# Rezoning Transportation Analysis

Petition Number: 2025-058

Date	Description
07-22-25	First Review (ME)
11-20-25	Second Review (ME)
04-23-26	Third Review (ME)
05-27-26	Fourth Review (ME)

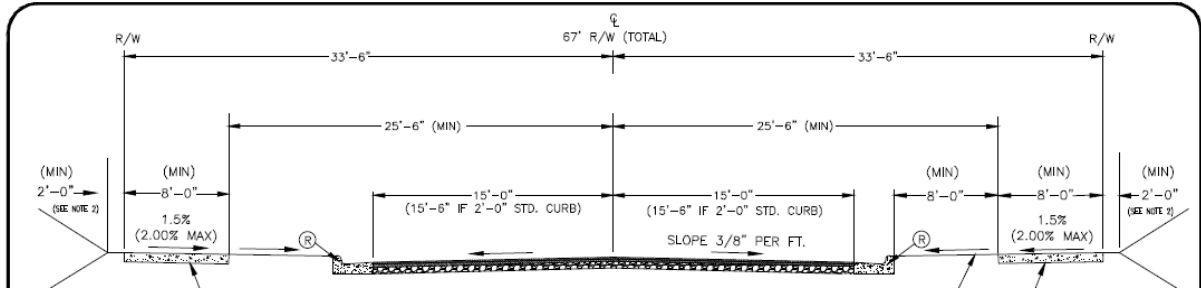
a. ~~Hondures Drive: Location of curb and gutter to be installed to 17.5 feet from the roadway centerline to accommodate CLDSM U-03A1 with a roadway typical section of a residential wide street.~~

~~Outstanding Comment from 11/20/25: Show curb and gutter along Hondures Drive as 2.5 foot curb and gutter with a 15 foot travel lane following CLDSM U-03A1 and to maintain uniformity with the existing curb and gutter type along Hondures Drive.~~

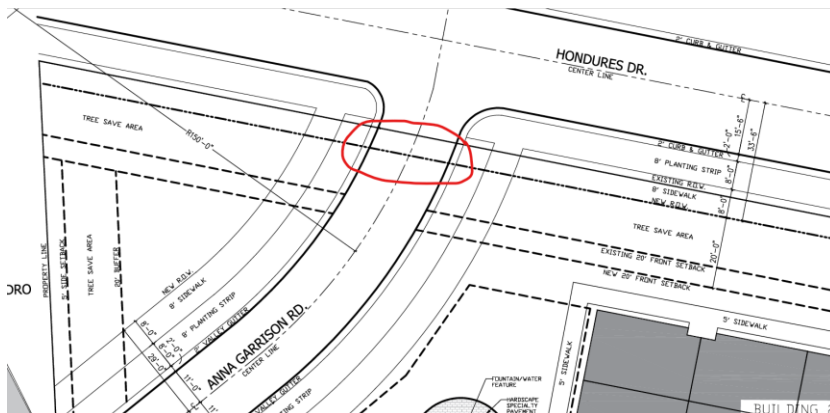
- ~~3. Revise site plan and conditional note(s) to commit to dedicate 33.5 feet right-of-way from the road centerline for Honduras Drive and internal public roads. The site plan shall label and dimension the right-of-way from the road centerline.~~

**Outstanding Comment from 11/20/25:** Provide conditional notes committing to dedicate 33.5 feet right-of-way from the road centerline for Honduras Drive and 62-foot right-of-way for the extension of Anna Garrison Road. Change label of "NEW ROW" in site plan to "PROPOSED ROW". Remove the proposed ROW across Anna Garrison Road circled below. The proposed ROW for Honduras Drive should meet the proposed ROW for the Anna Garrison Road extension at the intersection corners. Show a similar line type for the proposed ROW on Anna Garrison Road extension as shown for Honduras Drive.

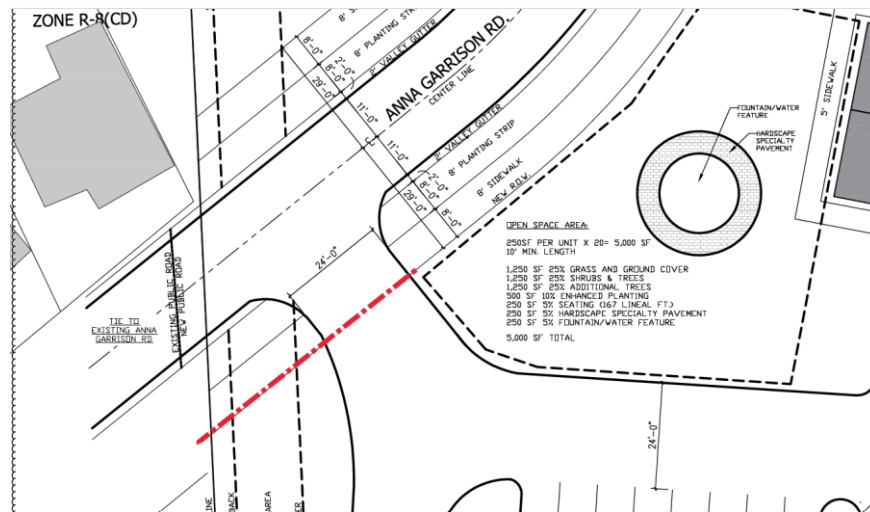
- ~~4. Revise site plan and conditional note(s) to commit to construct an 8-foot planting strip, and an 8-foot sidewalk on Honduras Drive per CLDSM U-03A1. The site plan shall label and dimension both items from the back of curb and gutter.~~

~~**Outstanding Comment from 11/20/25:** Provide a conditional note committing to construct an 8-foot planting strip and 8-foot sidewalk on Honduras Drive per CLDSM U-03A1.~~

~~**Clarifying Comment 4/23/26:** The site plan shows a sidewalk at the back of curb then a planting strip. These two infrastructure items are in the incorrect order. Revise site plan to show the planting strip at the back of curb followed by the sidewalk per CLDSM U-03A1.~~

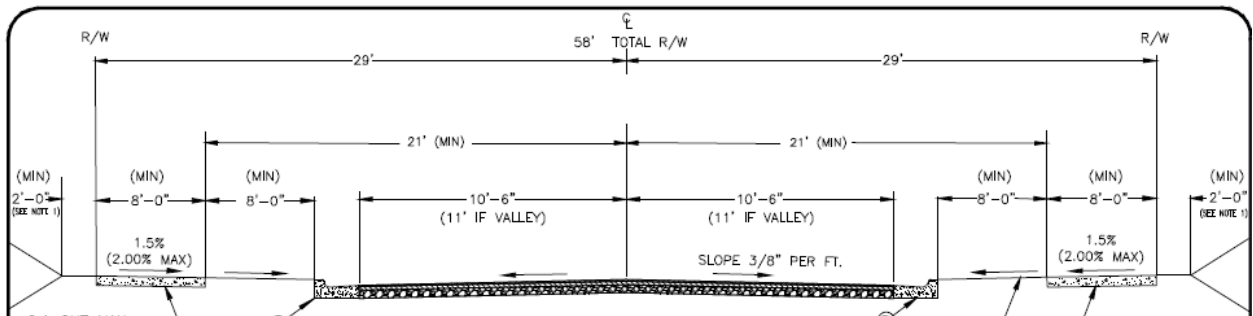
- ~~7. Revise site plan and conditional note(s) to commit to site internal public road being designed to a residential medium following CLDSM U-02B with an 8-foot sidewalk, 8-foot planting strip, and 58-foot right-of-way. The road alignment should serve as an extension of and tie into Anna Garrison Road, and intersect with Honduras Drive in alignment with the driveway for parcel 08702C99. The minimum horizontal radius for the internal public road must be 150 feet. Please see below.~~

~~**Clarifying Comment 11/20/25:** Provide a conditional note committing to construct an 8-foot planting strip and 8-foot sidewalk for the Anna Garrison Road extension per CLDSM U-02B and 58 feet of right-of-way. Also provide a note that the minimum horizontal radius for the road will be 150 feet for the road extension and that it will intersect Honduras Drive in alignment with the driveway for parcel 08702C99.~~
